January 10, 2015

01262-01336 Version2

Safety Recall: Driver's (Left) Side Curtain Airbag May Not Inflate Properly

(Supersedes 14-079, dated December 12, 2014, to revise the information highlighted in yellow.)

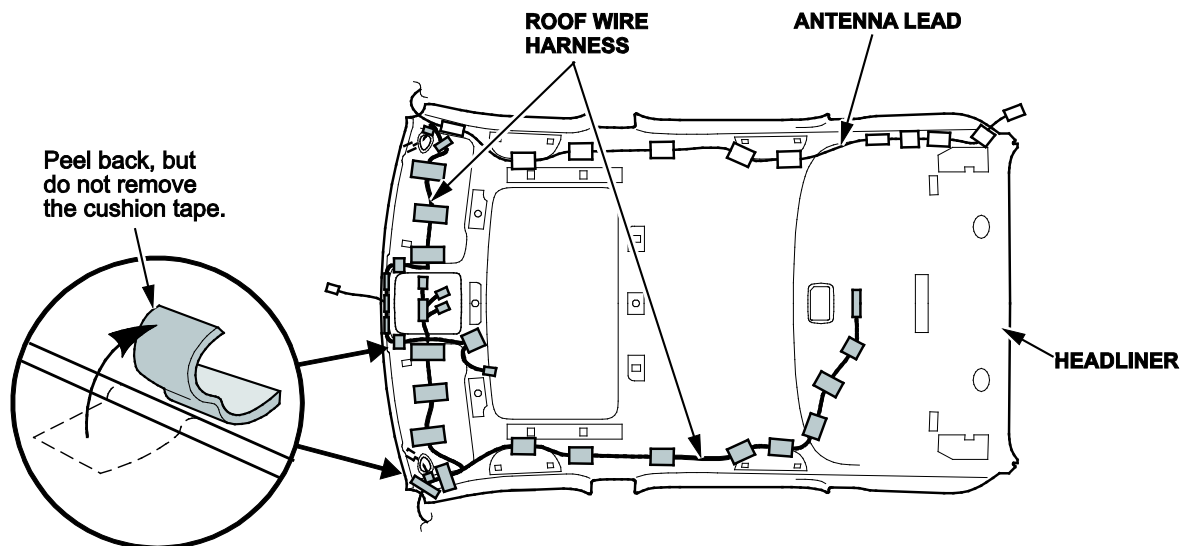
Do not disconnect the roof wire harness from the driver's dash area; once the headliner is lowered, detach the roof wire harness from the headliner by carefully peeling back just enough tape to remove the harness.

- Do not remove all of the tape; it will be reused.
- Make sure the roof wire harness is out of the way so that it does not get tangled with the headliner when you remove it from the vehicle.
- Leave the AM/FM antenna attached to the headliner.
